ECE/TRANS/WP.29/GRRF/2006/20
6 July 2006

PROPOSAL FOR DRAFT AMENDMENTS TO REGULATION No. 13
(Braking)

Submitted by the expert from the European Association of Automotive Suppliers (CLEPA)

"DIAGRAM 1

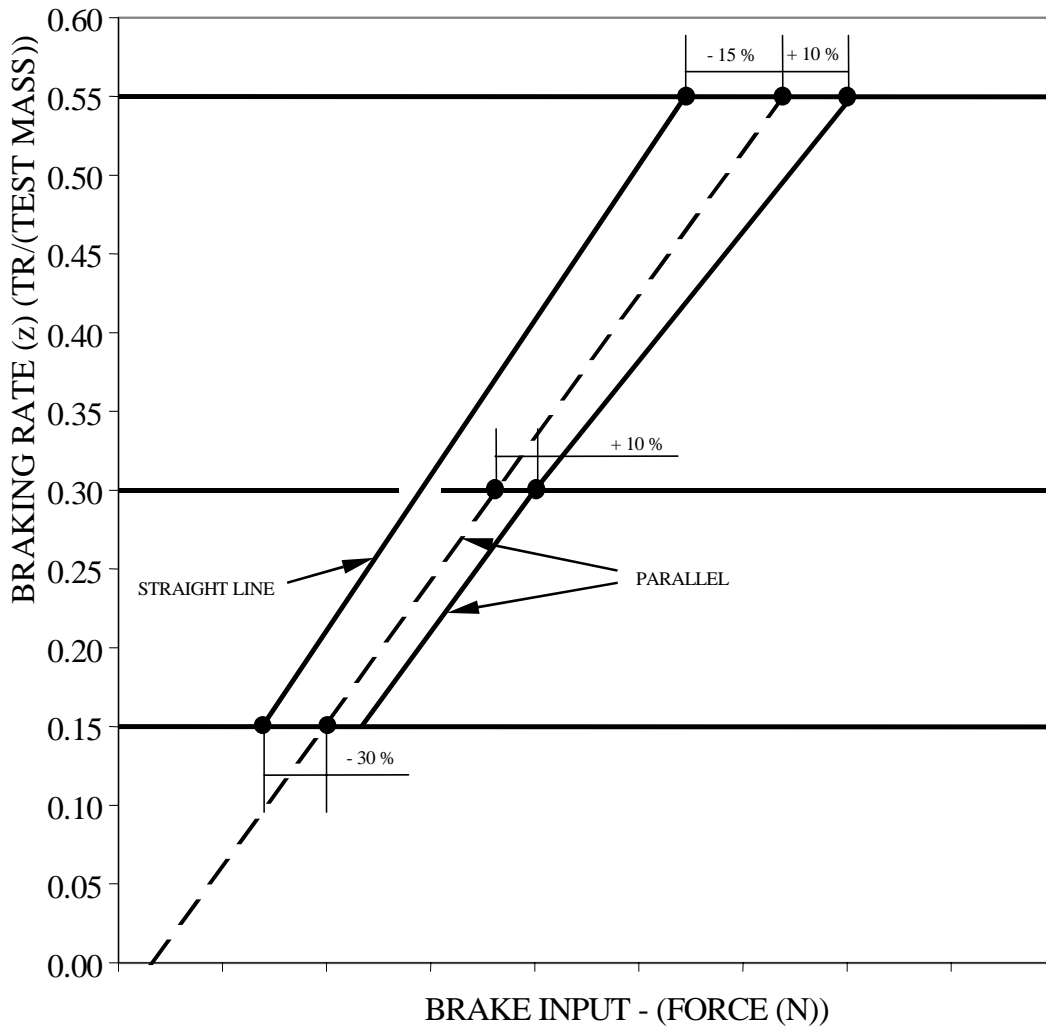
Diagram 1, amend to read:

The brake factor characteristic is typically curved. Therefore, it is proposed to modify the upper boundary line in diagram 1 of Annex 19 to take into account this fact. The two-slope line is replaced by a single slope.

Furthermore the relative tolerance of this section is increased from 10 to 15 per cent at 0.55 braking rate relative to the brake input, and from 20 to 30 per cent at 0.15 braking rate relative to the brake input. These changes are not opposed to the 10 series of amendments to ECE Regulation No. 13. The focus of series 10 refers to the area beneath 1bar. The proposed changes on the other hand touch the area above a deceleration of 15 per cent.

The lower boundary line remains unchanged, thereby maintaining the same minimum standard, but the method of dimensioning is changed from braking rate to brake input. This change in dimensioning is to have the same dimensioning method throughout the diagram.
